ZMA-1-25 Faison Reserve Planned Unit Development February 19, 2026 Joint Public Hearing Questions & Comments

Council/LURB Questions, Comments, & Recommendations:

Figure 1--Partial view of Knightdale-ETJ zoning map. Map extents are south of Mingo Creek, North of Hwy 87, Hodge Rd on the west and Smithfield Rd on the east. Data are from <https://maps.raleighnc.gov/iMAPS/> accessed on 2/21/2026.

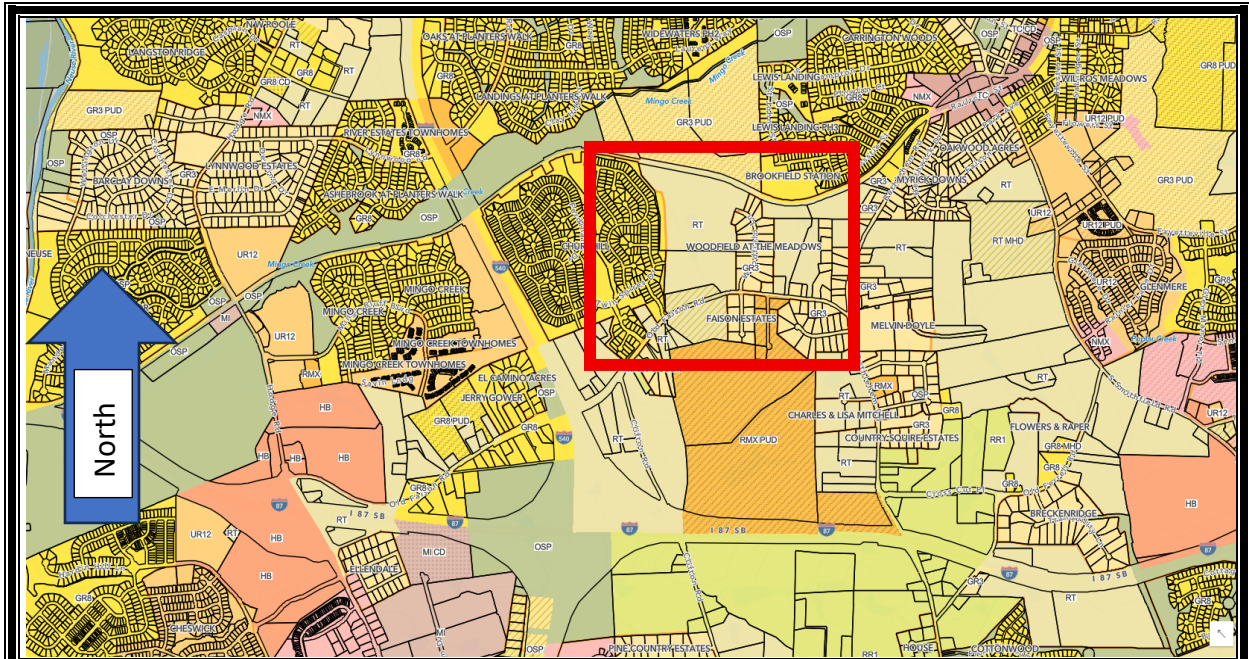
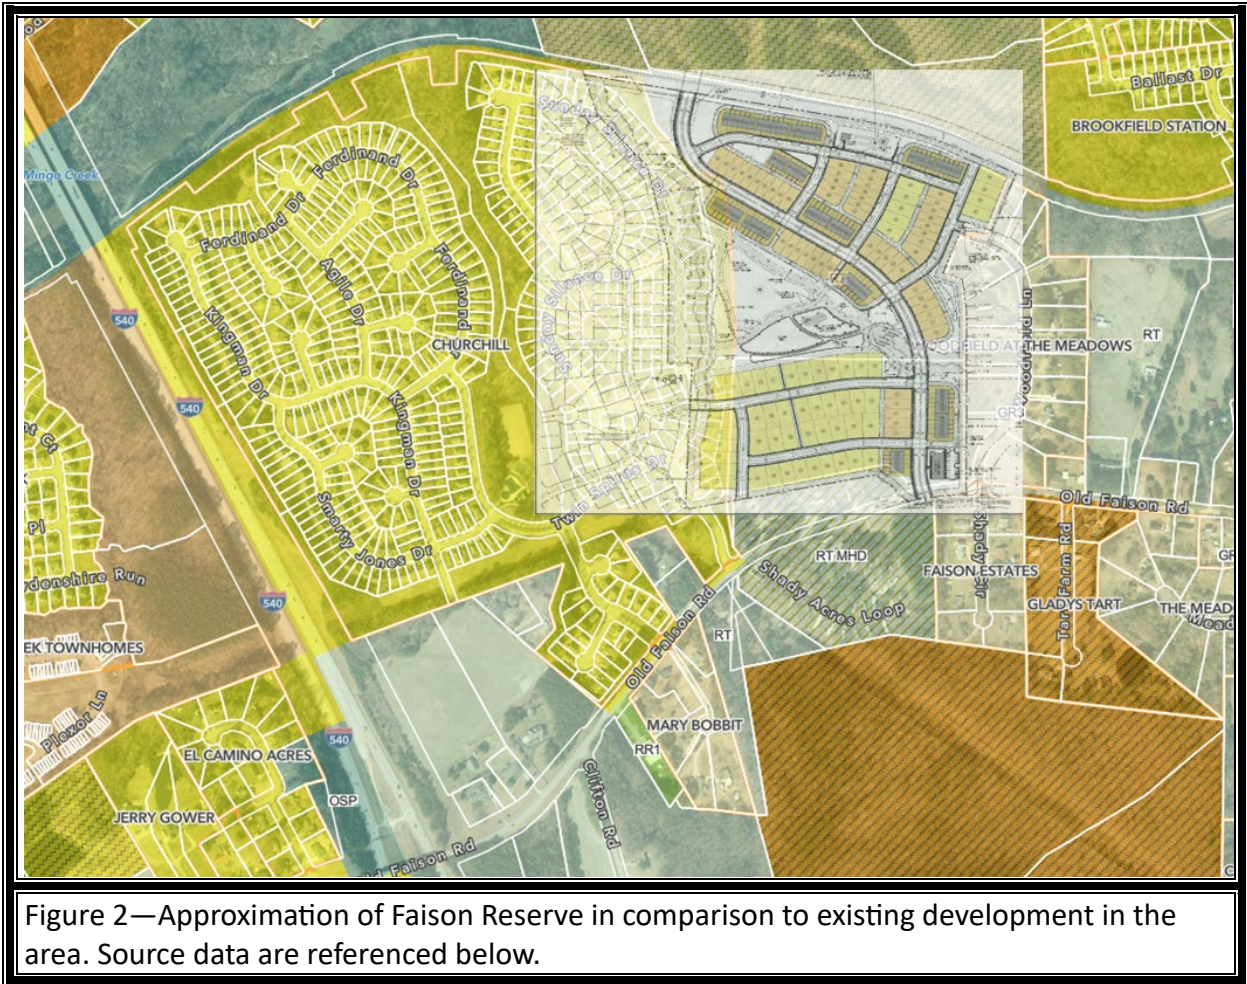
Currently the typical zoning along Old Faison Rd is GR8, GR3, RT and most recently NMX. The red box in Figure 1 shows the area where Faison Reserve is proposed to be built and the adjacent Woodfield Ln neighborhood. With the exception of the recently rezoned Lyndon Oaks subdivision, it can be seen that the remaining properties are either medium density GR8 or a lower density GR3, RT, RR1. We ask that the LURB and Town Council help to keep our remaining area from having high density housing such as Townhomes, and continue with areas to be developed as single family homes (SFH).
